RE: SEP TOPIC IX-3, DRESDEN 2

Enclosed is a copy of our draft evaluation of Systematic Evaluation Program Topic IX-3, Station Service and Cooling Water Systems.

SEP REVIEW  
OF  
STATION SERVICE AND COOLING  
WATER SYSTEMS  
TOPIC IX-3  
FOR THE  
DRESDEN NUCLEAR POWER PLANT UNIT 2

Figure 1. Low Pressure Coolant Injection/Containment Cooling System P&ID

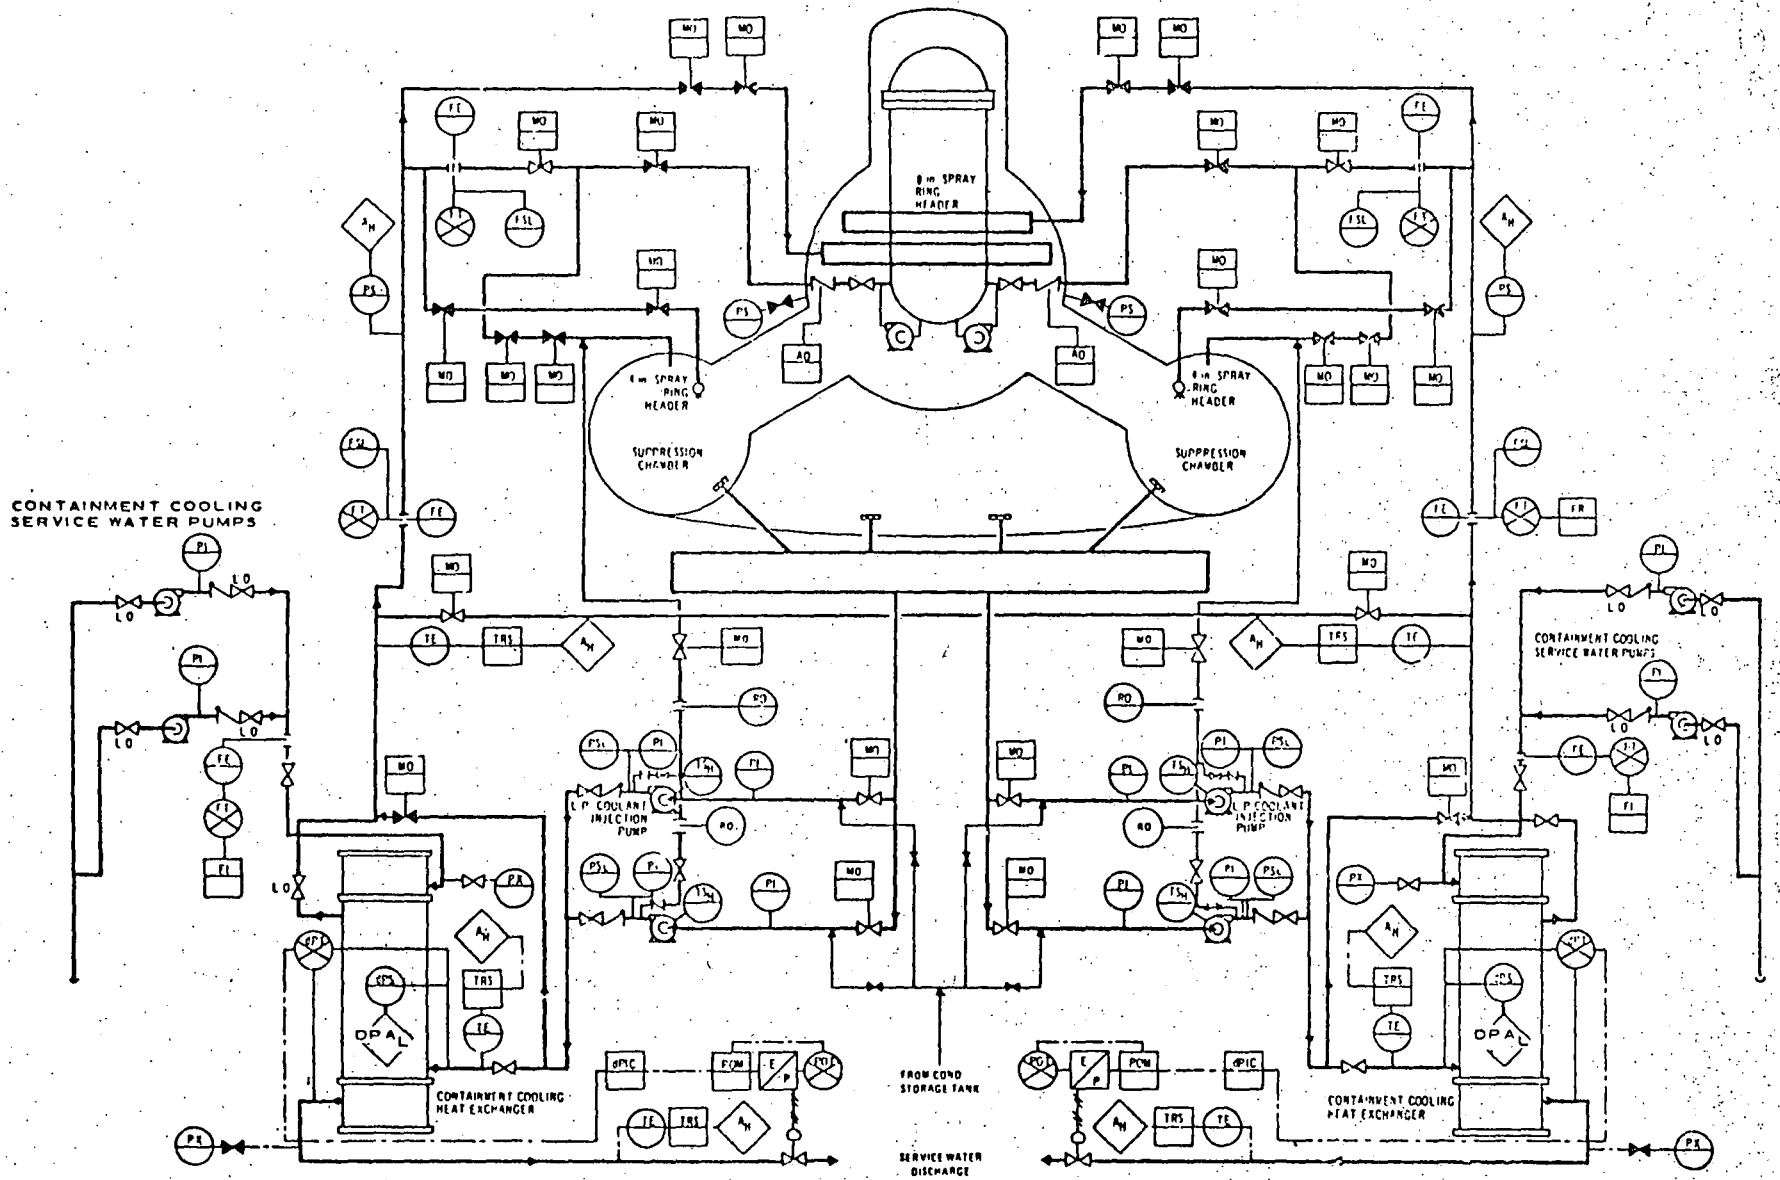
heat removed from the reactor core or from the containment by the LPCI is deposited in the suppression chamber (torus) water, and from there it is transferred to the CCSW system through the LPCI/CCSW heat exchangers (Fig. 1).

The sequence of actions followed by the operator to initiate CCSW cooling is to stop two of the LPCI pumps (all of which were automatically started by the ECCS actuation signal) and to start two CCSW pumps. The LPCI pumps must be stopped to provide sufficient electrical load capability on the emergency diesel generator to start the CCSW pumps. During this sequence, one LPCI pump must remain in operation to provide reactor core cooling.

The minimum combination of LPCI/CCSW pumps available occurs after a postulated loss of offsite power and the single failure of one of the emergency diesel generators. The cooling capability of the minimum combination (1 LPCI pump, 2 CCSW pumps) was analyzed in Section 5.2 of Reference 4 with the conclusion that adequate cooling was available to accommodate the post-LOCA heat input to containment.
